Special Conditions: Gulfstream Aerospace Corporation Model GVIII-G700 and GVIII-G800 Series Airplanes; Dynamic Test Requirements for Single- and Multiple-Occupant Side-Facing Seats With or Without Airbag Systems

ACTION: Final special conditions.

Discussion of Comments

Figure 2

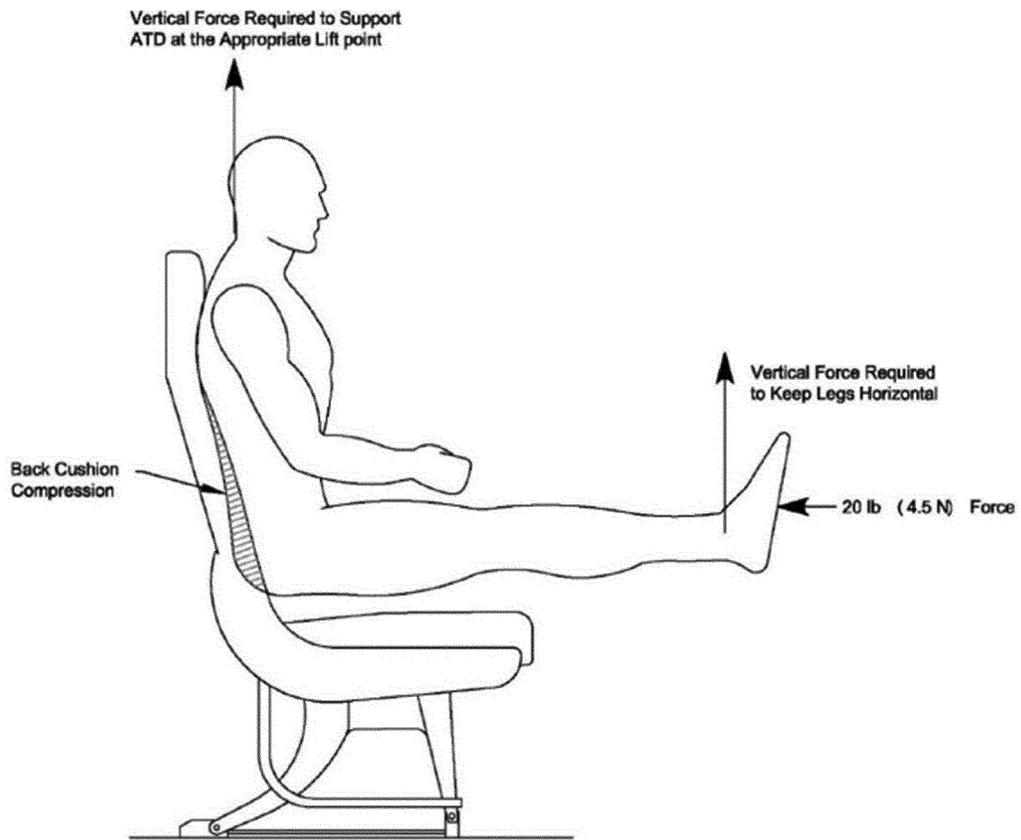
2. The commenter stated that the proposed special conditions paragraph 1.e(1)(b) may cause confusion, in that the word "bottom" is singular and the word "feet" is plural. This wording, according to the commenter, could lead to an interpretation that the force of about 20 pounds (lbs) may be applied to each foot, plus it is not specified that the force be applied uniformly. The commenter also suggested a specific revision to the text of this paragraph to address these concerns. The FAA disagrees that there is ambiguity or that a change is necessary. The 20 lbs of force is the total force applied to the bottom of the feet. The text of the special condition is similar to the language of FAA Policy Statement PS-ANM-25-03-R1 "Technical Criteria for Approving Side-Facing Seats." No changes were made to these special conditions as a result of this comment.

(b) Applying a horizontal x-axis direction (in the ATD coordinate system) force of about 20 pounds (lbs) (89 Newtons [N]) to the bottom of the feet of the ATD with the legs straight, to compress the seat back cushion.

Figure 3

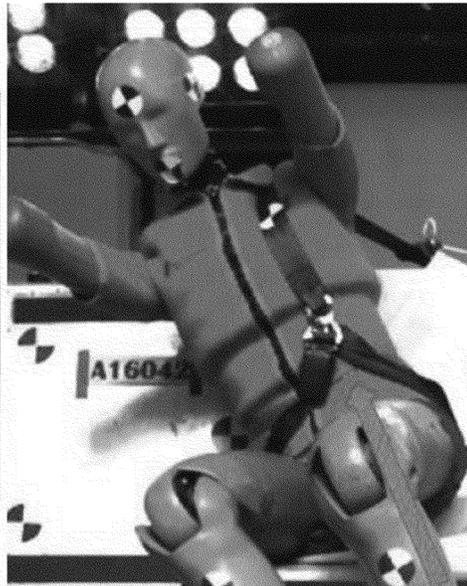
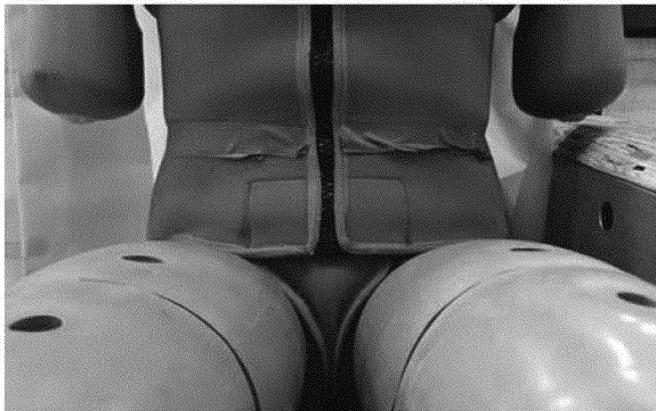
content of paragraph 2.g. of the special conditions. The commenter suggested adding a colon at the end of paragraph g., and that subsequent special conditions should be numbered below that paragraph. The commenter also stated that paragraph 2.g. does not explicitly state when lap belt tension must be limited to 250 lbs, and that the rationale for the limit in the Civil Aerospace Medical Institute (CAMI) report does not have to be specified in the proposed special conditions. The commenter further stated that paragraph 2.g. has a typographical error in that data should be filtered at "CFC 600" as defined in SAE JS211-1 "Surface Vehicle Recommended Practice." The FAA agrees with most of the comments received on paragraph 2.g. The FAA has revised the formatting of paragraph 2.g. to reflect the requirements clearly. The FAA does not concur with the commenter that the data should be filtered at CFC 600 versus 60. Sixty is the correct value for belt loads in SAE JS211-1.

(1) A measurement of the belt loop load during the time when the belt moves above the pelvis (submarining) must not exceed 500 lbs (2,225 N) (*a 250 lb (1112.5 N) lap belt tension limit*). Data must be filtered at CFC 60 as defined in SAE J211. To evaluate the pelvic restraint performance using this criterion, three things are needed:

(a) A clear indication of when the belt moves above the pelvis. Loose clothing can make it difficult to determine where the top of the pelvis is, and in turn make it hard to discern exactly when the belt moved above it. This can be improved by marking the top of the pelvis clearly and by positioning the cameras so that

the position of the belt, relative to the top of the pelvis can be observed throughout the test (see Figure 3).
